# SERVICE BULLETIN

M-890

SAFETY RECALL CODE 058

## XL ALTERNATOR/CLUTCH

Figure 1. Removal of Stator and Stator Mount

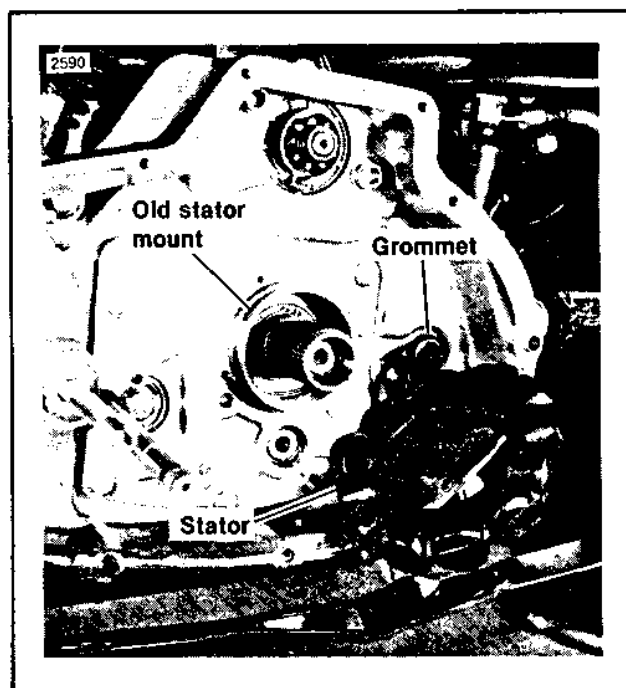
5. See Figure 1. Remove the stator mount located behind the stator and discard it (the stator mount may have been removed with the stator or remained on the access door).
6. See Figure 2. Place the new stator mount in position on the access door. Align the four counter bored holes in the stator mount with the four tapped holes on the access door.

**Figure 3. Tightening Stator Mount Screws**

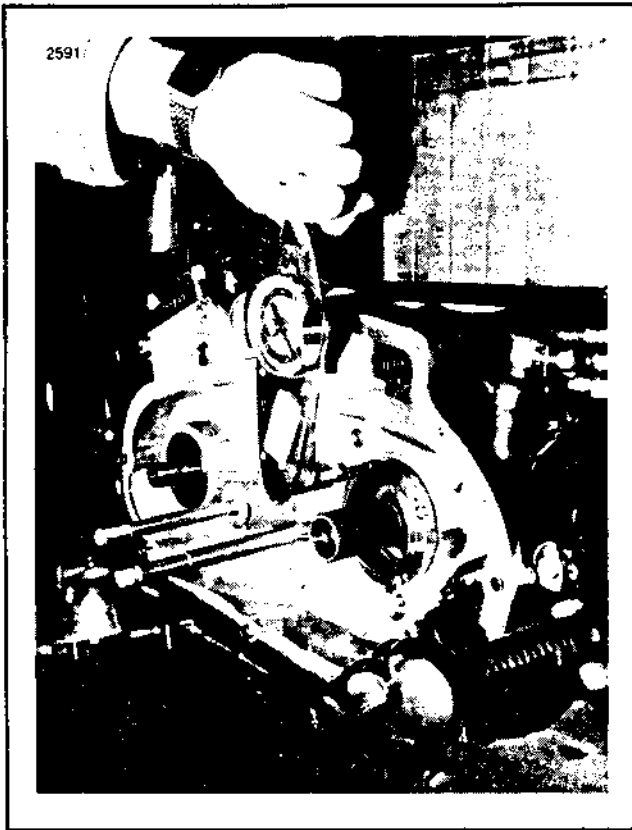
7. Apply 2-3 drops of Loctite 242 (blue) to the threads of the four Allen socket head screws, Part No. 2647, insert the screws thru the recessed (counter-bored) holes and tighten the screws to 30-35 in-lbs torque. See Figure 3.

**Figure 4. Stator Mounting Holes**

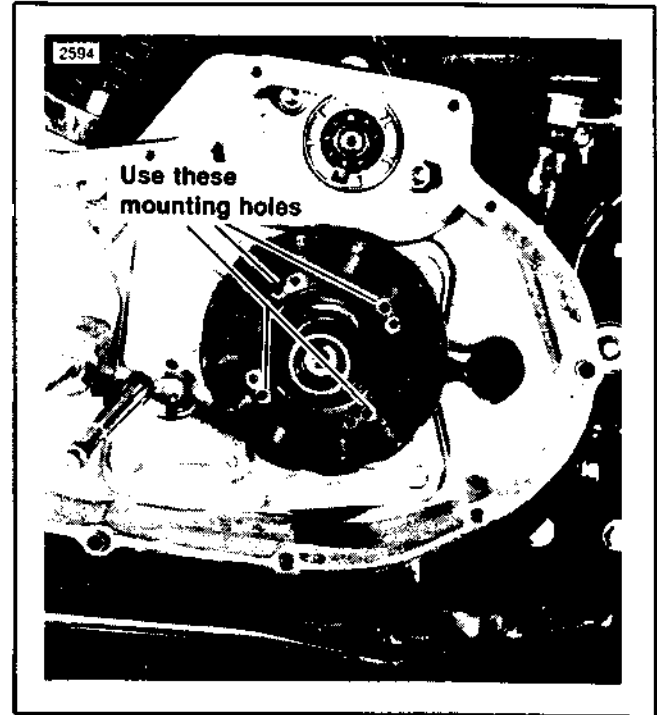
Inspect the replacement stator mounting holes identified in Figure 4 for burrs. If burrs are present, remove them with emery cloth so that stator will seat properly on the stator mount.

12. See Figure 4. Position the stator on the stator mount and align the holes indicated in Figure 4 with the tapped holes in the stator mount. Apply 2-3 drops of Loctite 242 to the threads of the four slotted head screws, Part No. 2653, and tighten these screws to 30-35 in-lbs torque.
